COUNCIL ASSESSMENT REPORT
SYDNEY WESTERN CITY PLANNING PANEL

PANEL REFERENCE & DA NUMBER	PPSSWC-334 – DA-50/2021/A
PROPOSAL	<p>Modification to Development Consent DA-50/2021 under Section 4.55 (2) of the Environmental Planning and Assessment Act 1979, for:</p> <ul style="list-style-type: none"> • Reconfiguration of internal apartment layouts including balcony design. • Revised basement ramp gradients with changes of basement levels, stormwater arrangement and OSD tank level and dimension adjusted. • Reconfiguration of car park layout to accommodate structural columns. • Site works including amendments to access ramp, retaining walls to accommodate revised ground level, revised front fence to accommodate services including hydrant booster assembly. • Amendment to Garbage storage and deletion of waste chutes. • Inclusion of lift overrun. • Amended façade materials and finishes. • Landscape design including the provision of an external bicycle parking area. • Amendment of Condition 21, 25,60, 62,151 and 179 • Deletion of Condition 155.

ADDRESS	23-25 Charles Street, Liverpool Lot 1 and Lot 2 DP500066.
APPLICANT	Hume Community Housing Association
OWNER	Hume Community Housing Associati

Figure 4: S4.55 – Proposed Basement

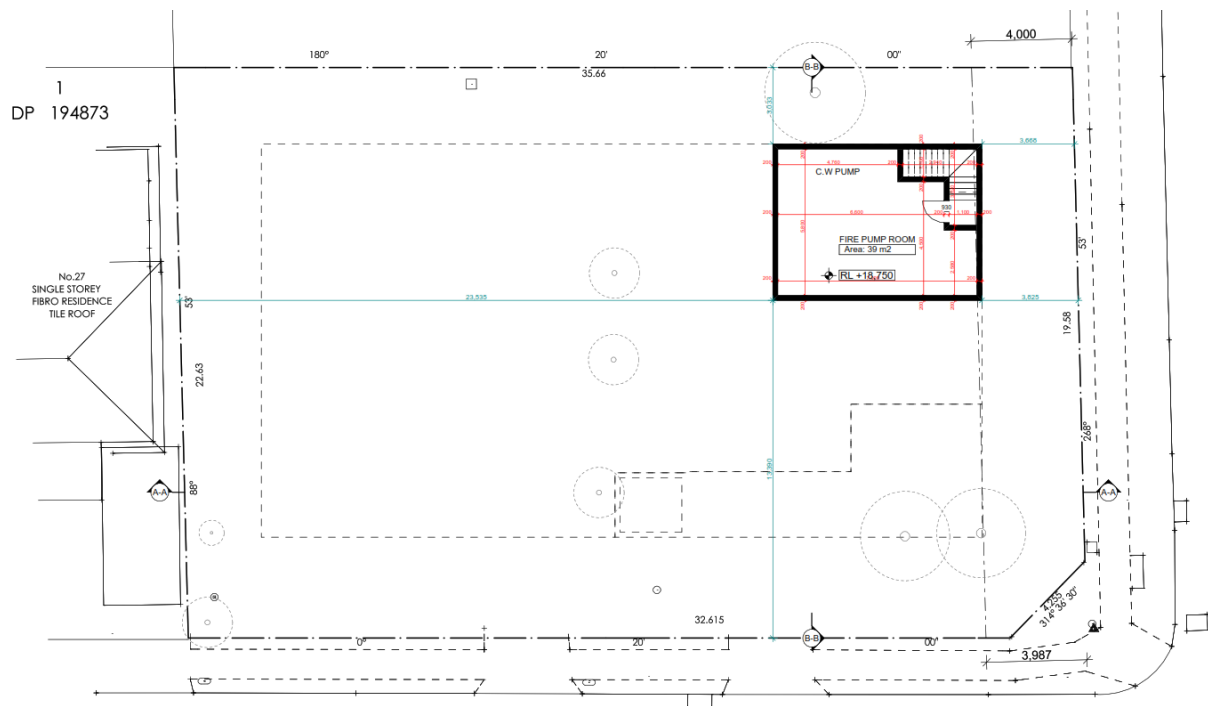
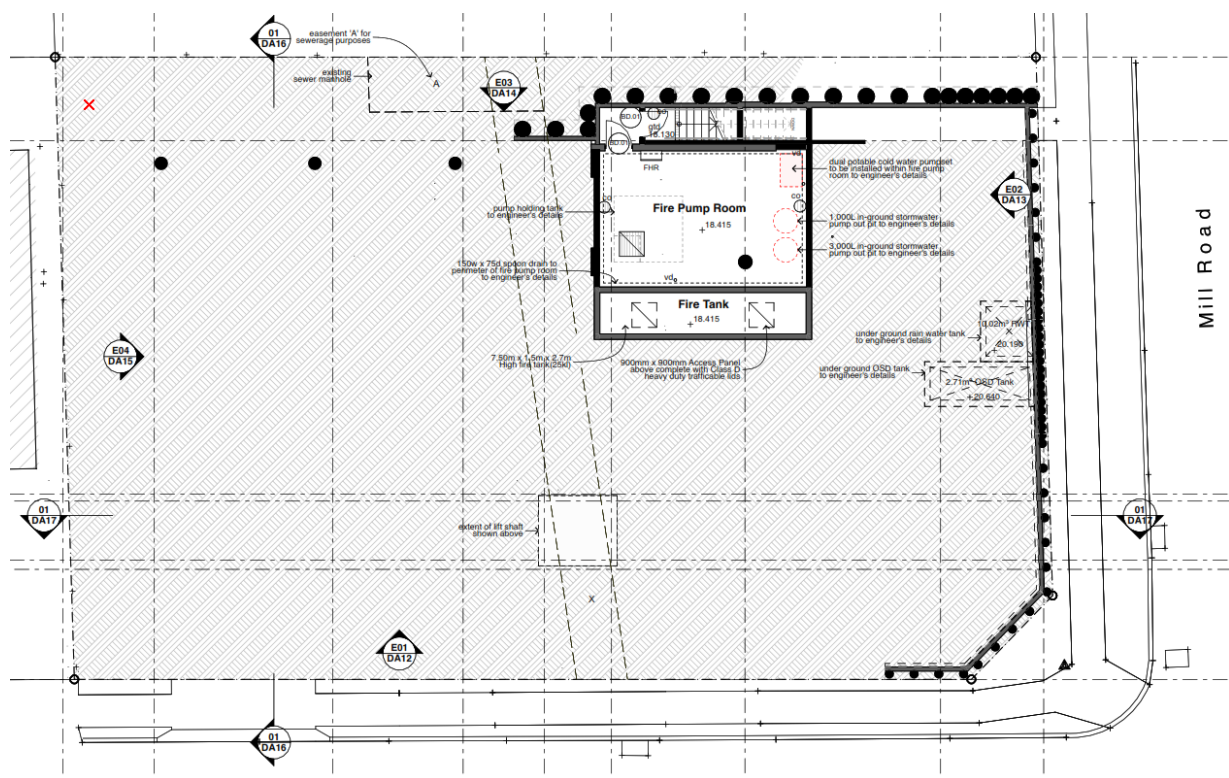
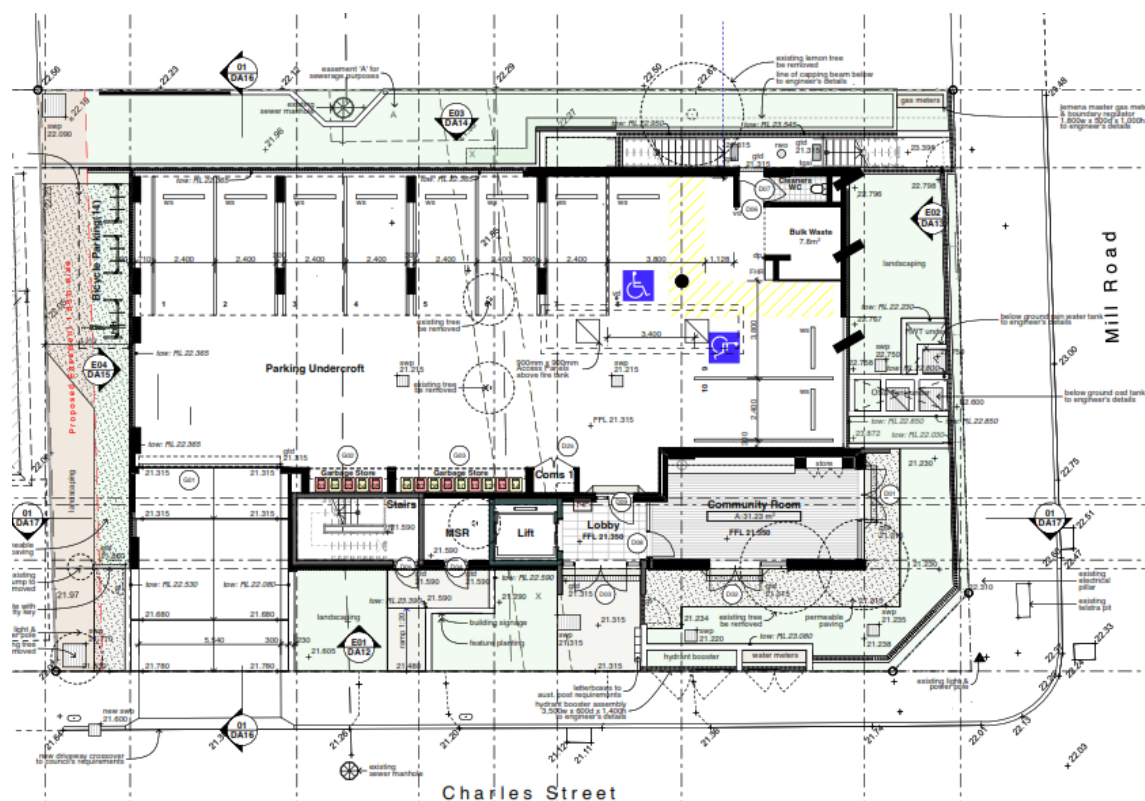
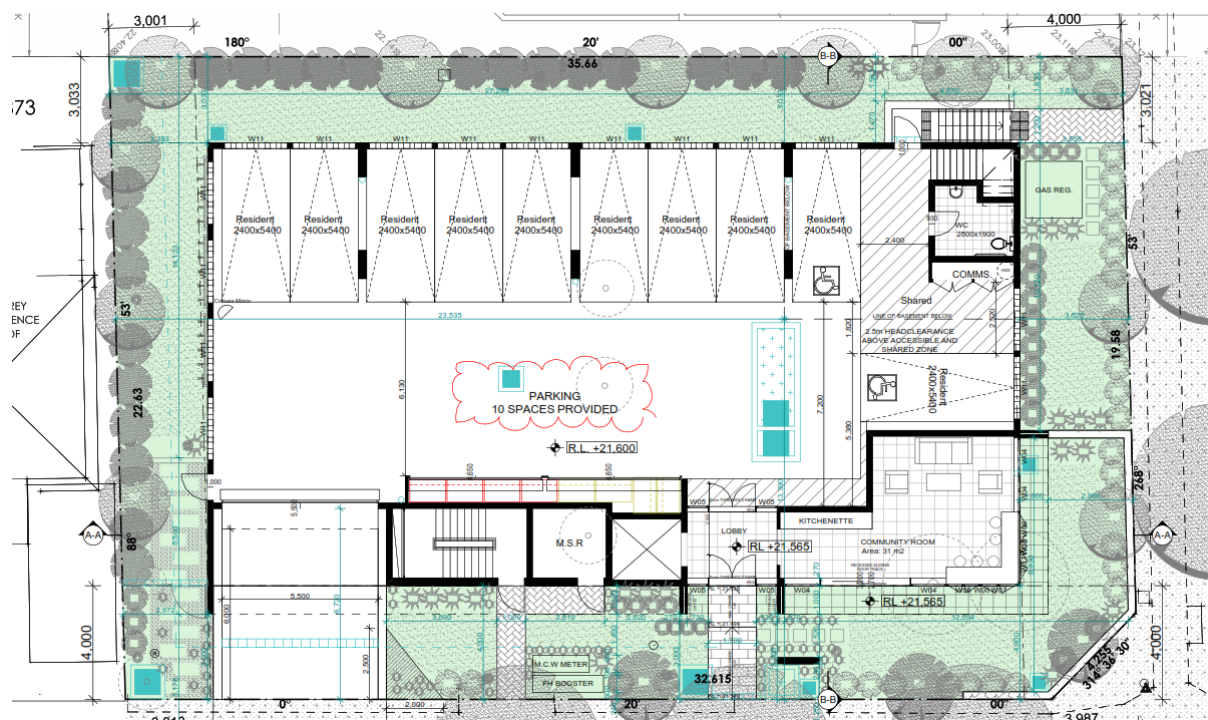
- The proposed modification amends the approved location of the fire pump room and includes the provision of a fire tank.
- This modification also includes the provision of an underground OSD tank.
- It expands the basement building envelope to the full extend of the side instead of the envelope of the build form above as previously approved under the parent application.

- The proposed modification amends the approved building envelope increasing the envelope from 444sqm to 461sqm which has not been included or justified by the applicant.
- Relocation and reconfiguration of fire exit stairs, which reduces the approved landscape and deep soil on site.

- Turning circles have not been provided to determine whether suitable circulation for parking spot 8, given the distance between the community room wall has been reduce from 7.2m to 5.2m.
- Increase in GFA of the community room.
 - This is an increase slightly in GFA which impedes the FSR across the site.
 - Deletion of the kitchenette.
- Communal open spaces have decreased from the approved 63sqm to 48sqm on the ground floor.
- Alteration to approved setbacks which includes the following:
 - Approved setback of 2.9m to the community room from Mill St.
 - Modification now proposes 3.9m to community room from Mill St.
 - Approved side setback of 3.825m to building envelope (carpark) from Mill St.
 - Modification now proposes a side setback of 4.37m to the building envelope (carpark) from Mill St.

This has not been addressed by the applicant in the information provided to Council.

Figure 8: Proposed S4.55 - Floor Plan L1 - Revision 3

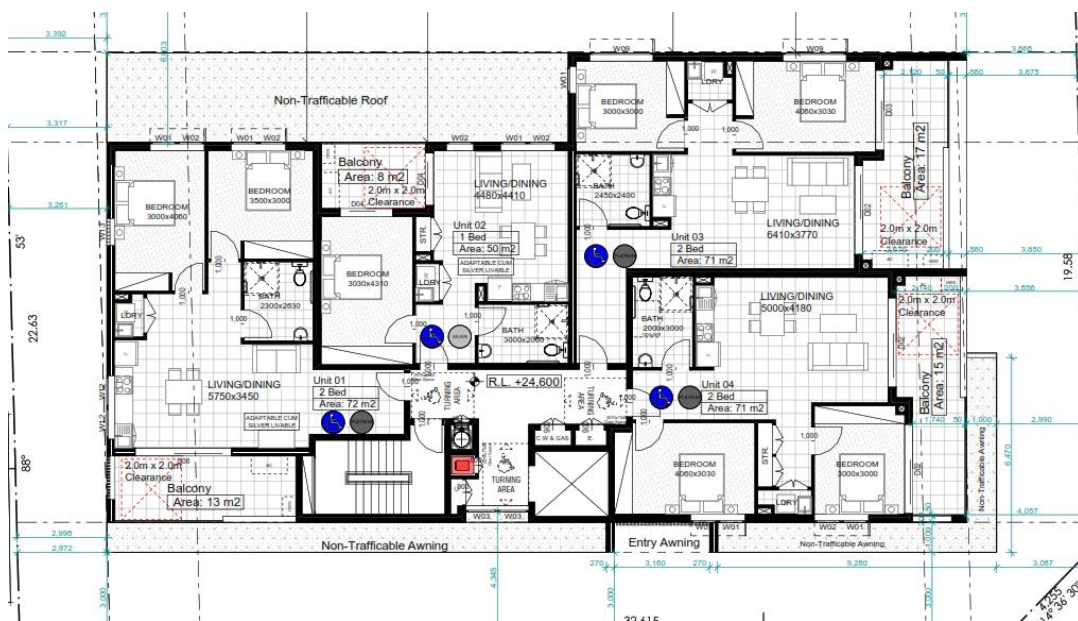
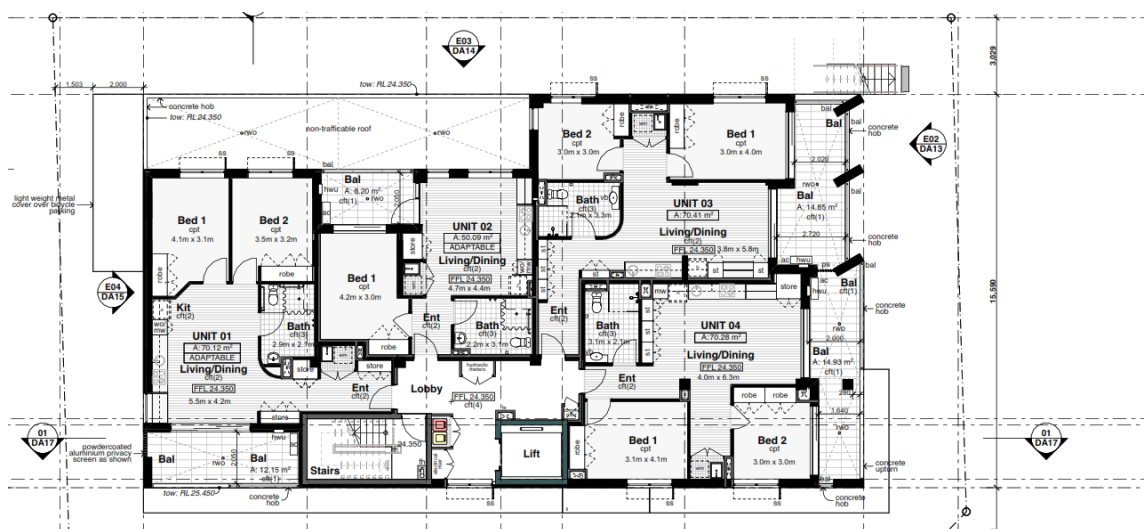
- The proposed modification amends the approved Unit GFA:

- Unit 1 has an approved GFA of 72sqm and is now proposed as 71sqm.
- Unit 3 has an approved GFA of 71 sqm and now is proposed as 70sqm.
- Unit 4 has an approved GFA of 71sqm and now is proposed as 70sqm.
- The modification also includes the amending of the balconies GFA:
 - Unit 1 has an approved Balcony area of 13sqm and is now proposed as 12sqm.
 - Unit 3 has an approved Balcony area of 17sqm and is now proposed as 14.85sqm
 - Unit 4 has an approved Balcony area of 15sqm and is now proposed as 14.93sqm
- Balcony widths have also altered.
- Units 3 and 4 are no longer listed as Adaptable units.
- The applicant states there is an increase in storage, when there is a reduction in storage for the following unit:
 - Units 2 – approved with 9m³ of storage now exhibits 4.4m³.

This has not been addressed by the applicant in the information provided to Council.

Figure 10: Proposed S4.55 Floor Plan L2 - Revision 3

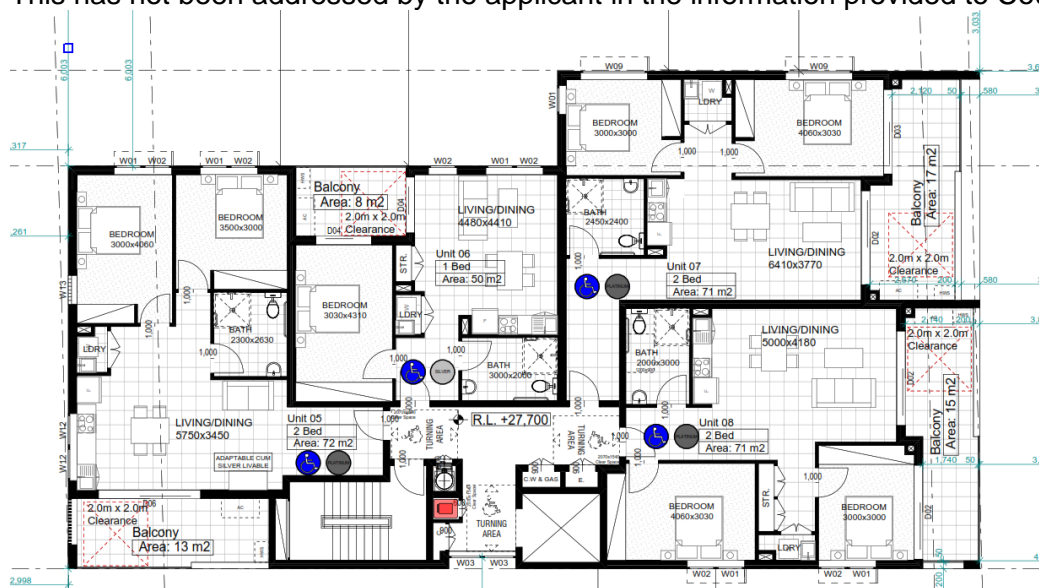
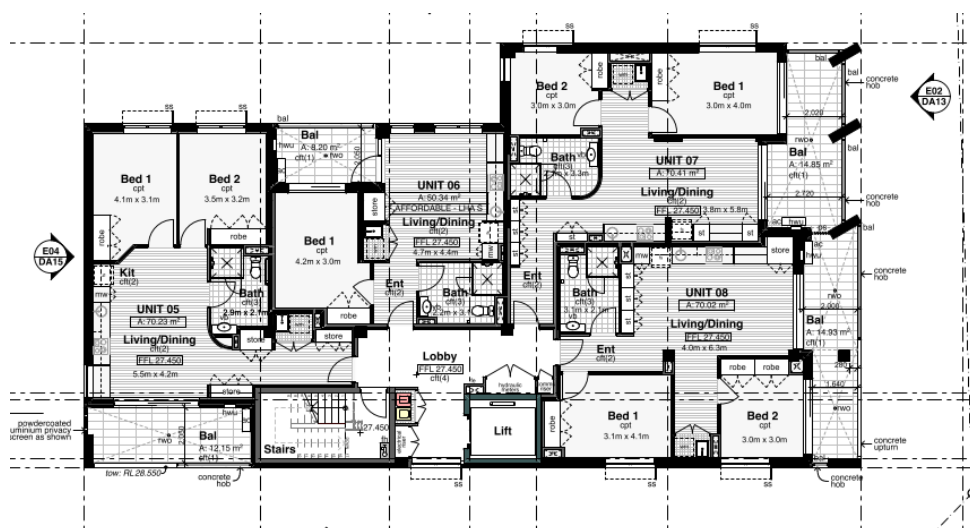
- The proposed modification amends the approved Unit GFA:
 - Unit 5 has an approved GFA of 72sqm and is now proposed as 71sqm.

- Unit 7 has an approved GFA of 71 sqm and now is proposed as 70sqm.
- Unit 8 has an approved GFA of 71sqm and now is proposed as 70sqm.
- The modification also includes the amending of the balconies GFA:
 - Unit 5 has an approved Balcony area of 13sqm and is now proposed as 12sqm.
 - Unit 7 has an approved Balcony area of 17sqm and is now proposed as 14.85sqm
 - Unit 8 has an approved Balcony area of 15sqm and is now proposed as 14.93sqm
- Balcony widths have also altered.
- Units 7 and 8 are no longer listed as Adaptable units.
- The applicant states there is an increase in storage, when there is a reduction in storage for the following unit:
 - Units 6 – approved with 9m³ of storage now exhibits 4.4m³ of storage. This is noncompliant with the ADG.

This has not been addressed by the applicant in the information provided to Council.

Figure 12: Proposed S4.55 Floor Plan L3 – Revision 3

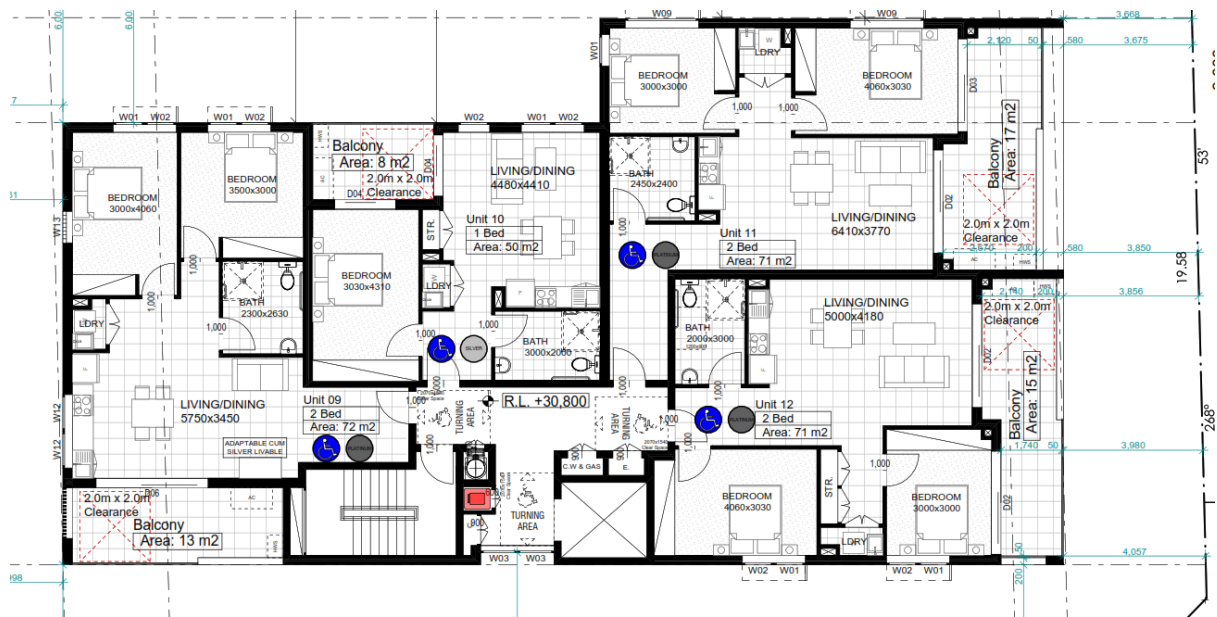
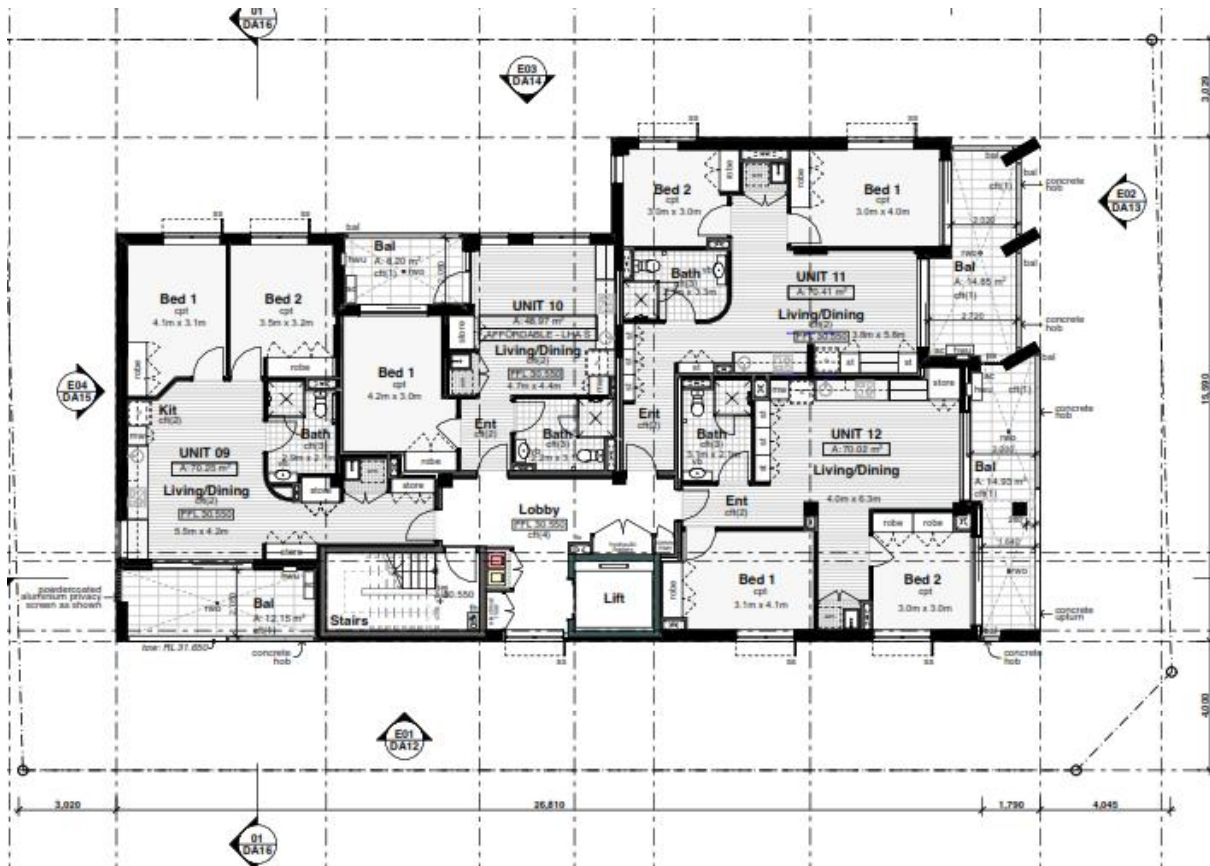
- The proposed modification amends the approved Unit GFA:
 - Unit 9 has an approved GFA of 72sqm and is now proposed as 71sqm.
 - Unit 10 has an approved GFA of 50sqm and now is proposed at 48.97sqm, this is now non-compliant with the ADG to be classified as a 1 Bedroom apartment, it should be considered as a studio.

- Unit 11 has an approved GFA of 71 sqm and now is proposed as 70sqm.
 - Unit 12 has an approved GFA of 71sqm and now is proposed as 70sqm.
- The modification also includes the amending of the balconies GFA:

- The applicant states there is an increase in storage, when there is a reduction in storage for the following unit:
 - Units 10 – approved with 9m³ of storage now exhibits 4.4m³ of storage. This is noncompliant with the ADG.

This has not been addressed by the applicant in the information provided to Council.

Figure 14: Proposed S4.55 Floor Plan L4 – Revision 3

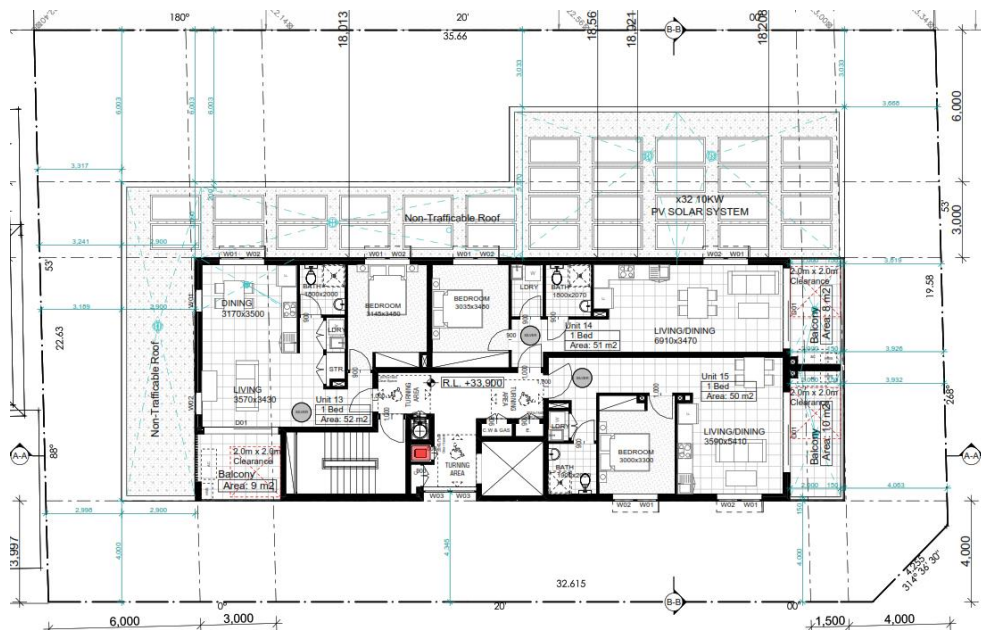
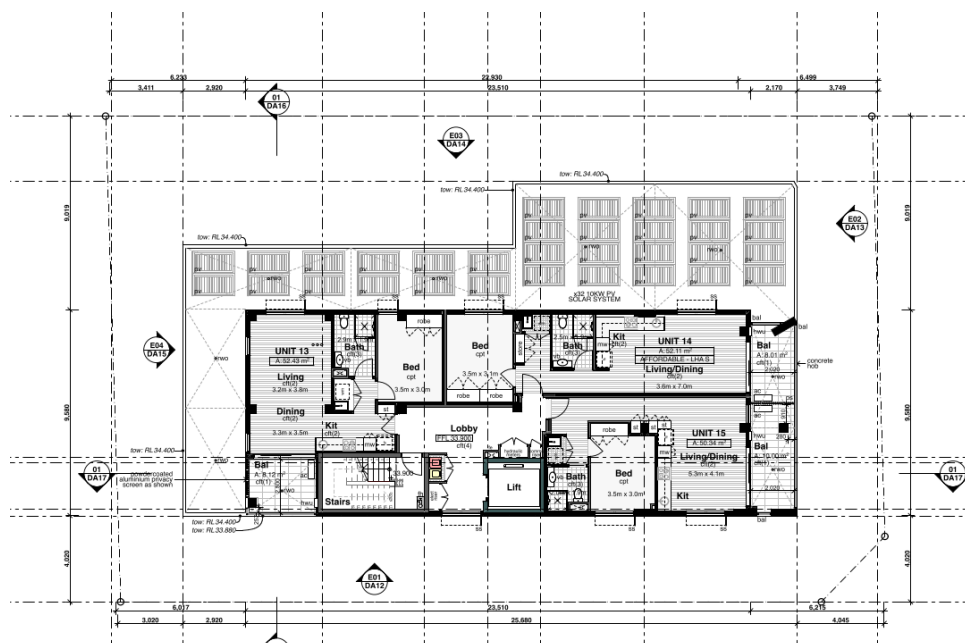
- The proposed modification amends the approved Units GFA:
 - Unit 13 approved GFA of 52sqm and is now 52.43sqm,
 - Unit 14 approved GFA of 51sqm and is now 52.11sqm,
 - Unit 15 approved GFA of 50sqm and is now 50.34sqm,
 - This is an increase slightly in GFA which impedes the FSR across the site.
- The modification also includes the amending of the balconies GFA:
 - Unit 13 has an approved Balcony area of 9sqm and is now proposed as 8sqm.
- Balcony widths have also altered.
- The applicant states there is an increase in storage, when there is a reduction in storage for the following unit:
 - Unit 13—now exhibits 2.9m³ of storage. This is noncompliant with the ADG.
 - Unit 15 now exhibits 4.7m³ of storage. This is noncompliant with the ADG.
